Comments of the Natural Resources Defense Council (NRDC) on the *California Energy Demand 2010-2020, Staff Revised Forecast, Second Edition*

Docket Number 09-IEP-1C

November 13, 2009

Figure E-1. Cumulative Efficiency Savings

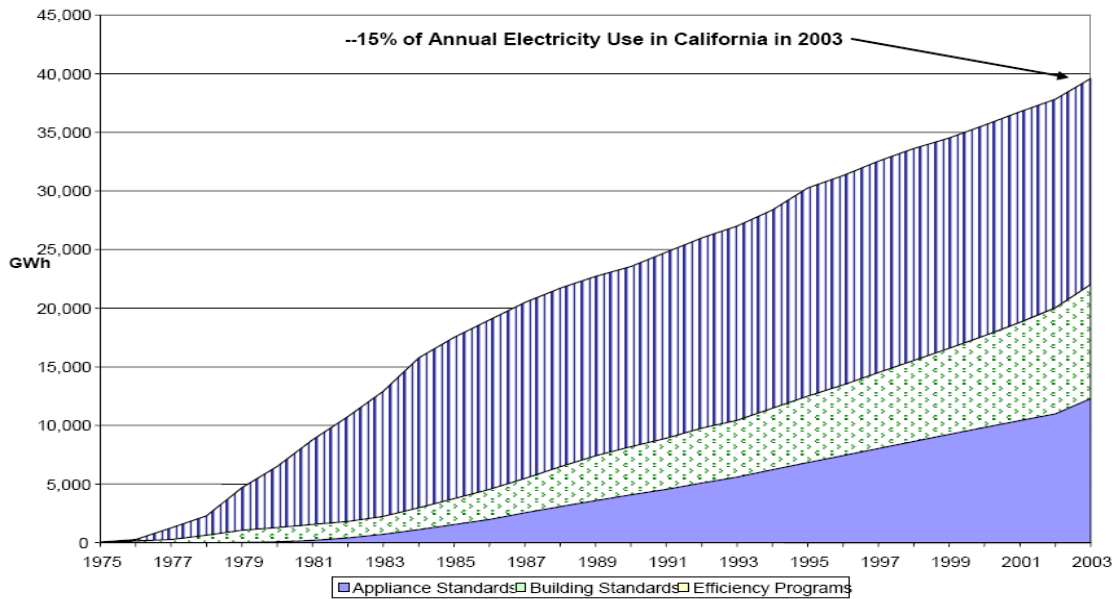
The CEC has published estimates of the cumulative impact of energy efficiency programs and codes and standards over the years. For example, in 2005, the CEC published the following graph:¹

Figure 159: Distribution of Efficiency/Conservation Consumption Savings by Source

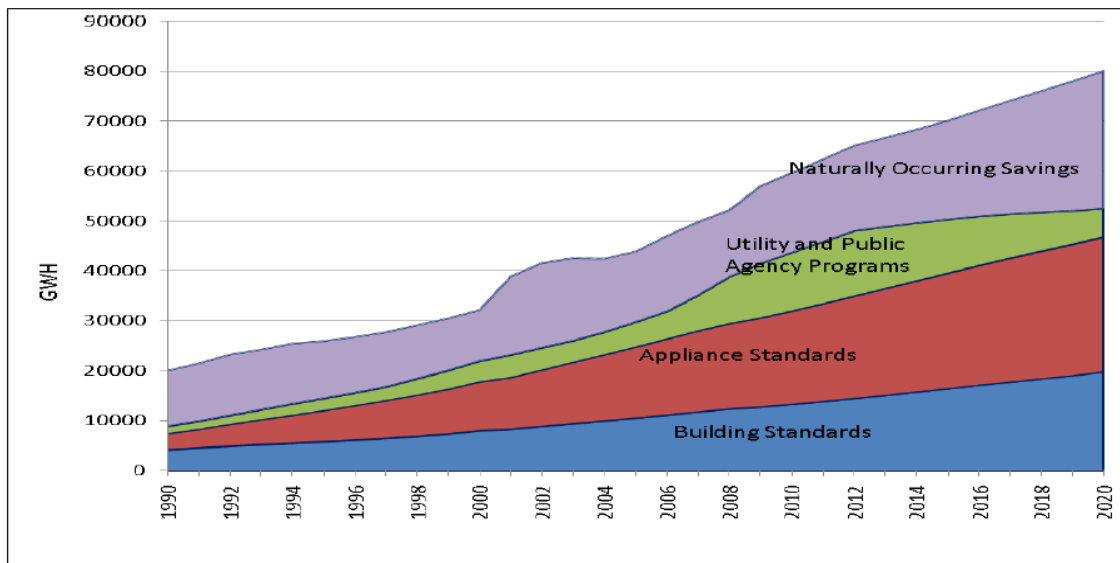
Figure 159 below in the Staff Forecast would dramatically change these past estimates, yet there is no clear explanation for why these changes are so dramatic.

The Staff Forecast discusses numerous detailed assumptions whose cumulative effect is illustrated in Figure 159 above, but it does not include a ‘big picture’ explanation of the changes in the results. NRDC has numerous remaining questions about the detailed assumptions, discussed below, and we believe it would be premature for the CEC to

adopt the revised efficiency estimates which differ so dramatically from the Commission's own past estimates without further analysis or explanation.
